**TENNESSEE VALLEY AUTHORITY
BROWNS FERRY NUCLEAR PLANT (BFN)
UNITS 1, 2, AND 3**

**TECHNICAL SPECIFICATIONS (TS) CHANGES TS-431 AND TS-418
EXTENDED POWER UPRATE (EPU)**

**RESPONSE TO ROUND 15 AND 16 REQUESTS FOR ADDITIONAL INFORMATION
(RAI) REGARDING STEAM DRYER ANALYSES, GROUP 3**

Figure EMCB.137/104-1: Pressure transfer from lattice cell in the Helmholtz solver to structural node in ANSYS model.

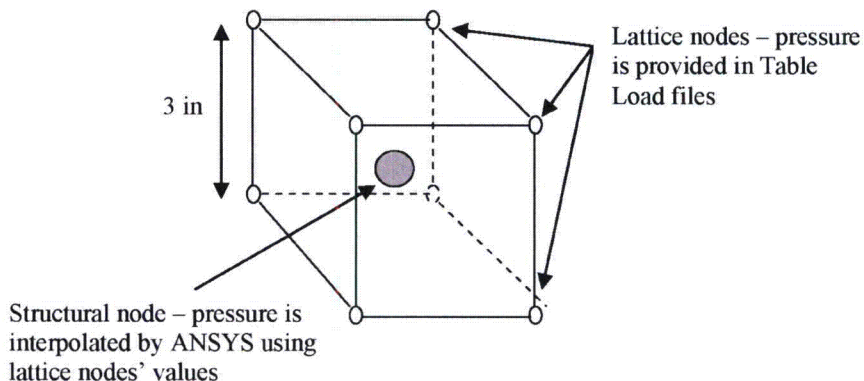
For Section 3.10 of the CDI Report 07-05P, provide a more detailed explanation regarding the means used to obtain the pressure difference at the surface of the steam dryer. Additionally, in this context explain the terms "Table Loads," "lattice nodes," and "eight forming nodes of the lattice cell."

Pressure differences across dryer surfaces are computed from the acoustic field by solving the Helmholtz equation for the pressure inside the steam dome, including the region inside the dryer, as a function of frequency (at 5 Hertz (Hz) intervals).

]] At a given point on the structural surface, \mathbf{R}_s , the applied stress is $P(\mathbf{R}_s)\mathbf{n}_s(\mathbf{R}_s)$, where $P(\mathbf{R}_s)$ is the acoustic pressure difference evaluated at \mathbf{R}_s and $\mathbf{n}(\mathbf{R}_s)$ is the local normal directed into the fluid. In order to impose this load numerically, ANSYS employs Table Loads, where the pressure difference field is represented on an $n_x \times n_y \times n_z$ regular lattice. Table Loads are text files with pressure difference values given at the lattice nodes, defined by their coordinates; thus, these

files are created for each frequency using nodes and pressure differences provided by the Helmholtz solver. In general the lattice nodes do not line up exactly with the surface in the structural model; however, the lattice spacing is made sufficiently small (3 inches) to accurately resolve the spatial variations of the acoustic field. For any surface point, R_s , the surface pressure difference force is obtained by first identifying the cube-shaped lattice cell containing the surface point. This cell will have 8 forming corners or vertices which contain acoustic pressure differences. These points may be slightly above or below the surface, depending on dryer geometry. However, all vertices are within 3 inches of R_s , and $P(R_s)$ is obtained by linearly interpolating the vertex values.

Figure EMCB.137/104-1 demonstrates the pressure difference transfer mechanism. One lattice cell is shown.

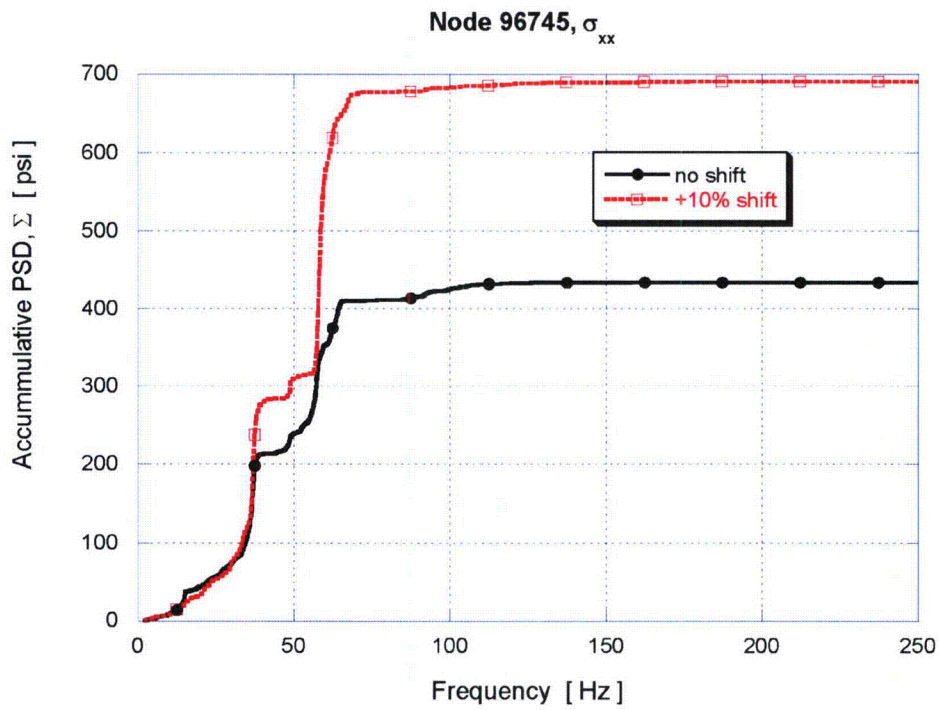
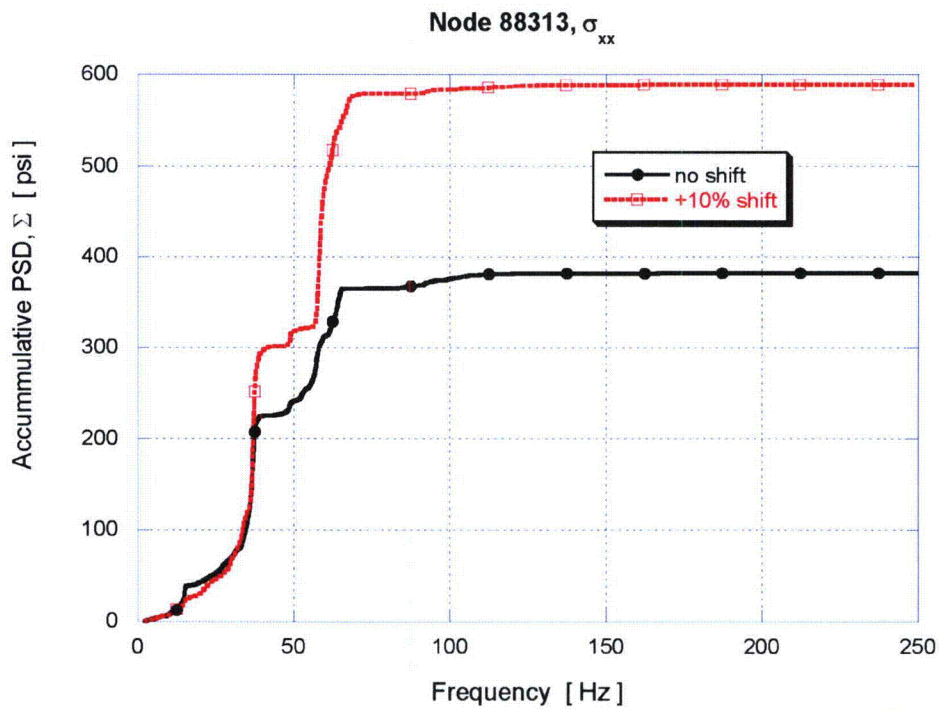
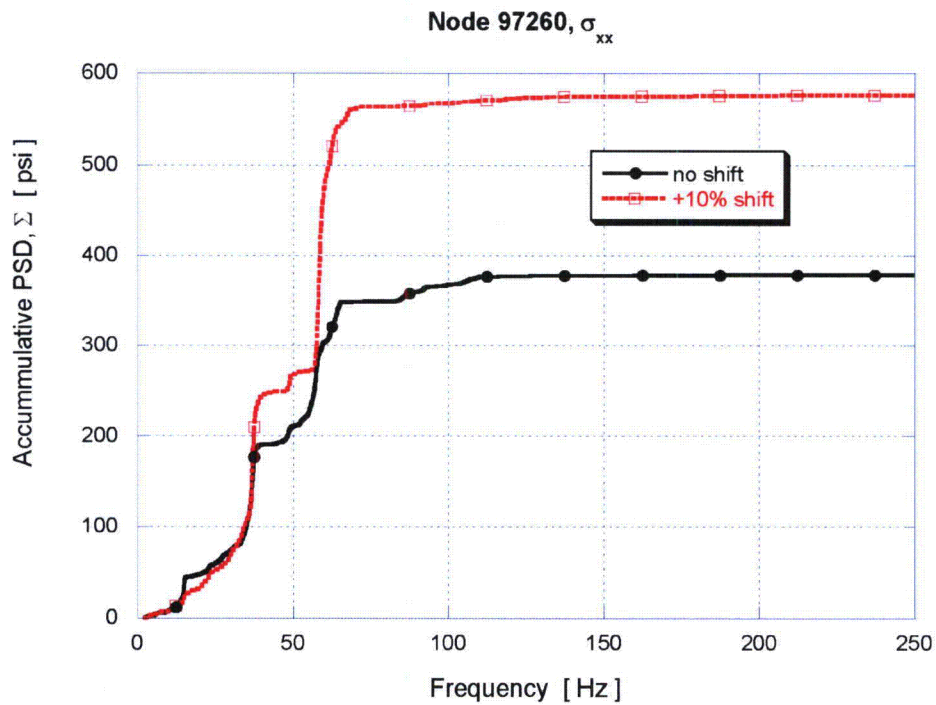
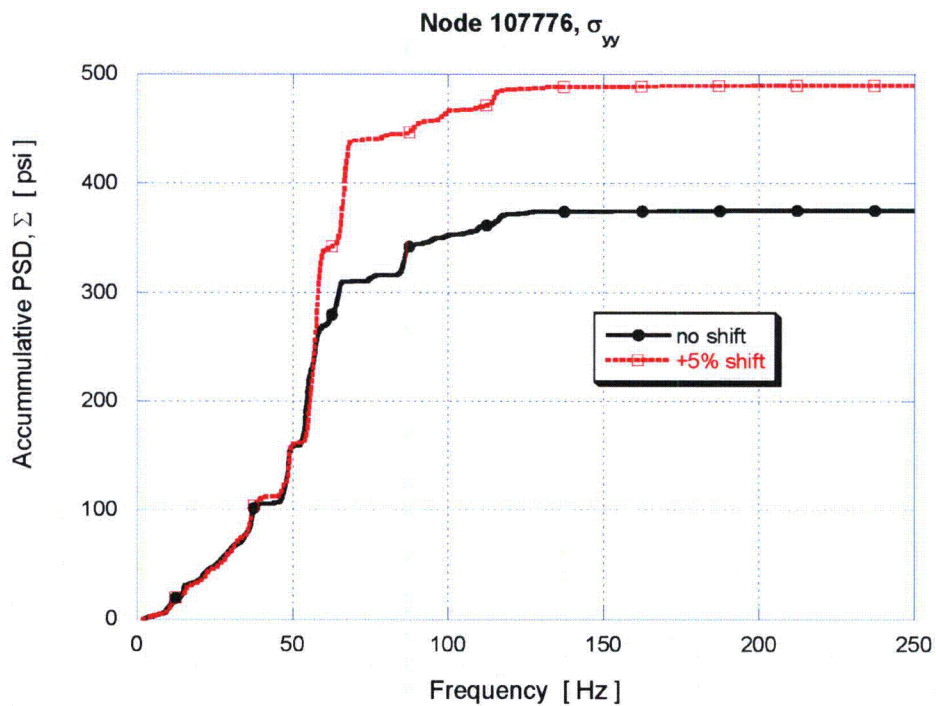
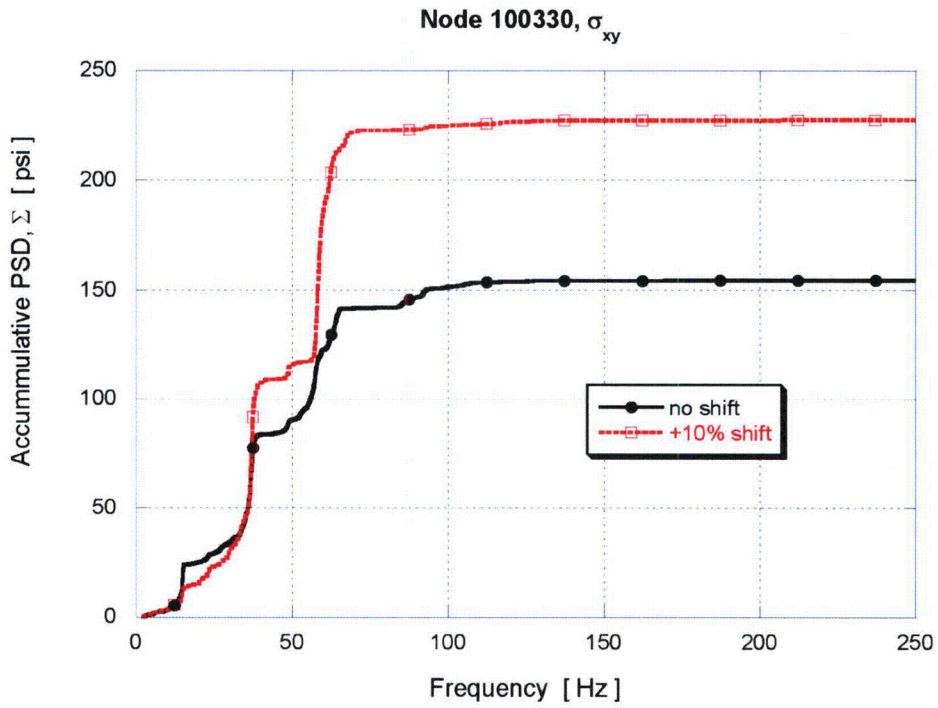
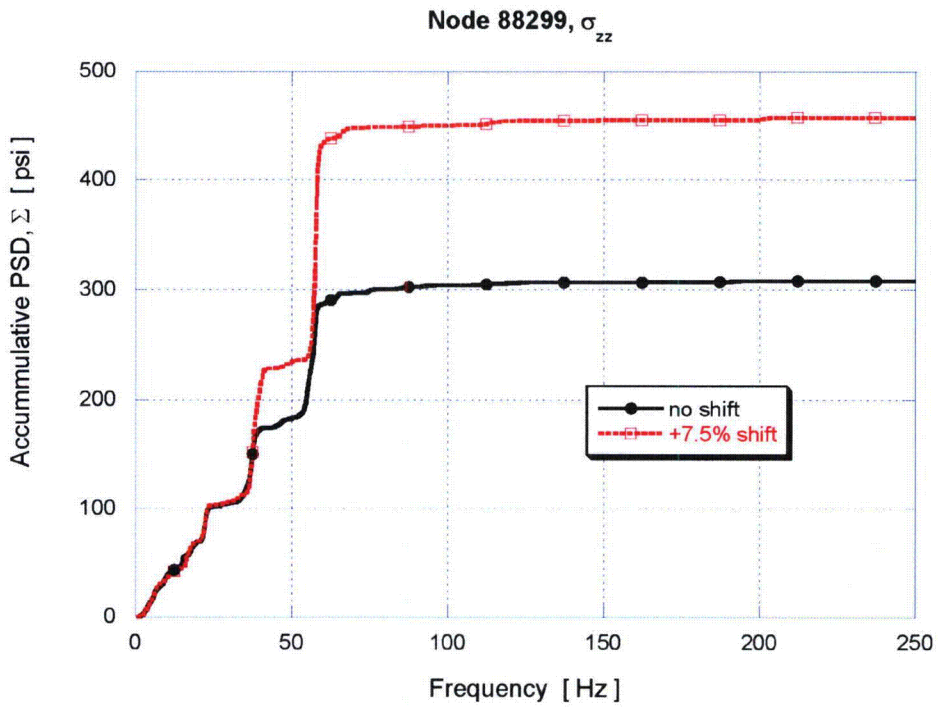
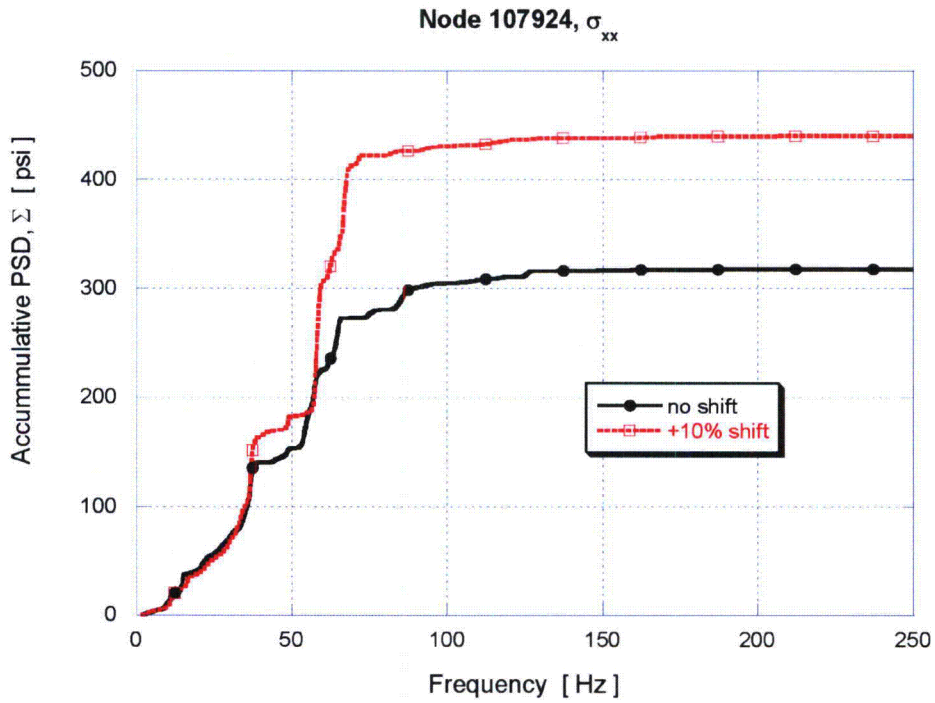
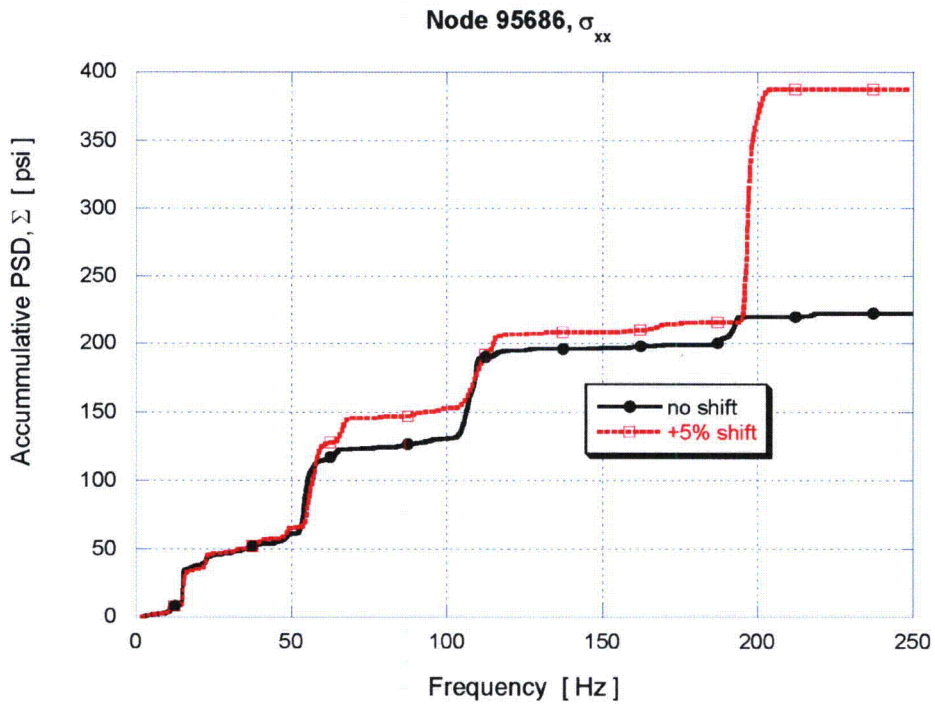
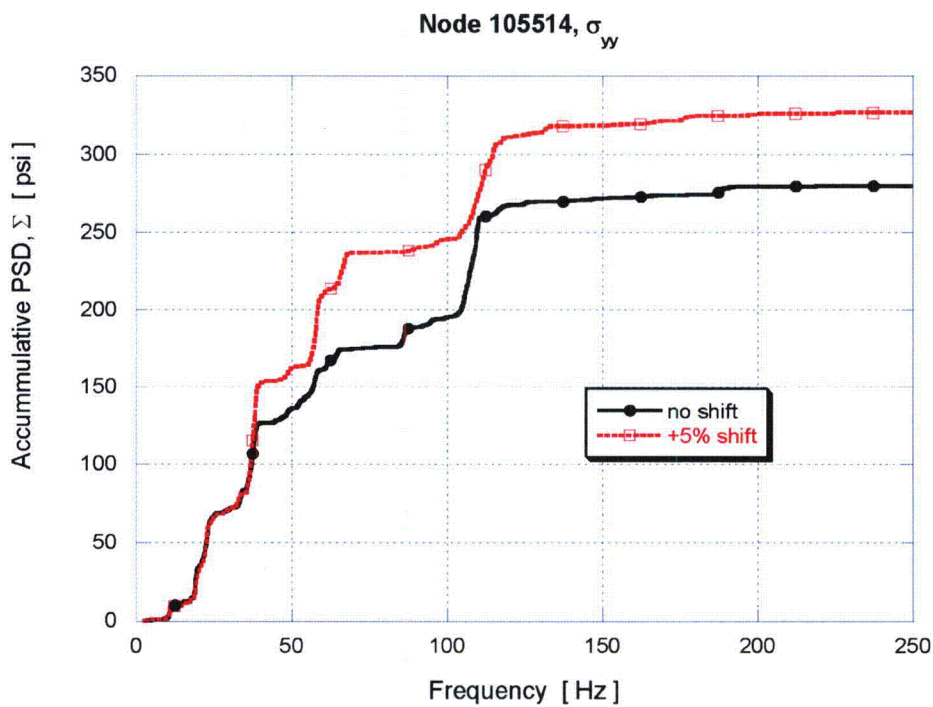
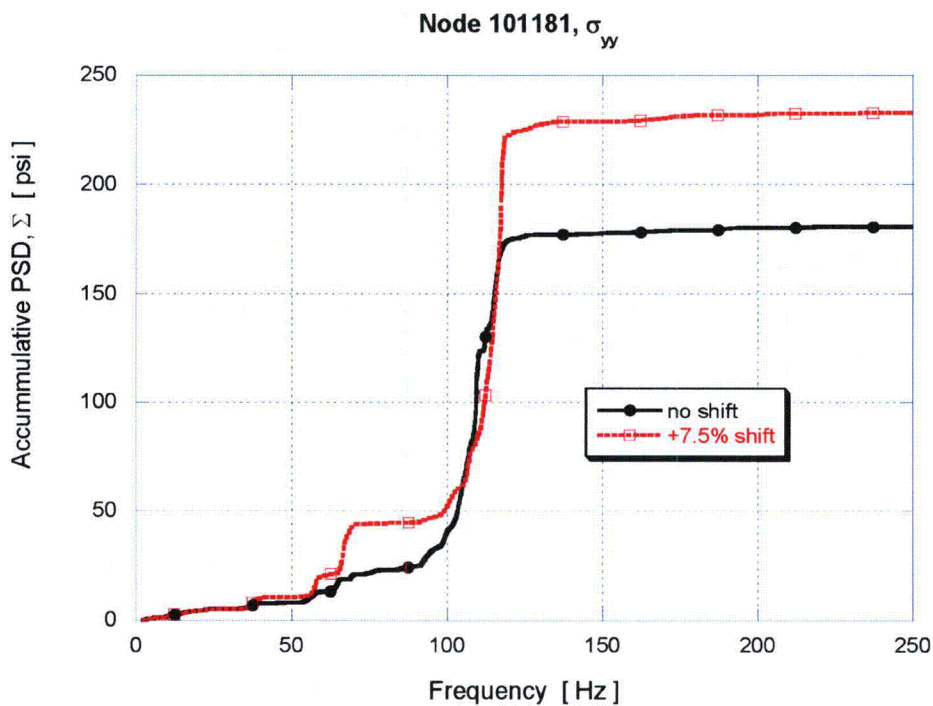
The minimum alternating stress ratio at CLTP, according to CDI Report 07-06P is 1.77 for the Unit 2 steam dryer when the 218 Hz signals are removed from the pressure loads. Identify the top ten frequencies that contribute most to the minimum alternating stress ratio.

As discussed during the December 10, 2007, meeting with the NRC, accumulative power spectral density (PSD) graphs have been generated for the ten steam dryer nodes exhibiting the lowest minimum alternating stress ratios. Figures EMCB.146/113-1 through 10 provide the requested graphs based on the stress analysis results with background noise removed presented in CDI Report No. 08-07P, "Stress Assessment of Browns Ferry Nuclear Unit 2 Steam Dryer," (Enclosure 2).

The accumulative PSDs at nominal operating condition and at the frequency shift yielding the lowest alternating stress ratios are shown in Figures EMCB.146/113-1 through 10. These curves show that the biggest increases in the accumulative PSDs: (i) tend to occur at lower frequencies (less than 75 Hz) and (ii) occur over the same frequencies both with and without frequency shift. The last three nodes comprise exceptions to (i).

- 37 Hz, which appears in most of the plots;
- 58 Hz, present in most of the plots and dominant in the first seven;
- 106 Hz, most pronounced in nodes 95686, 105514 and 101181.
- 197 Hz present in node 95686 at the +5% shift.
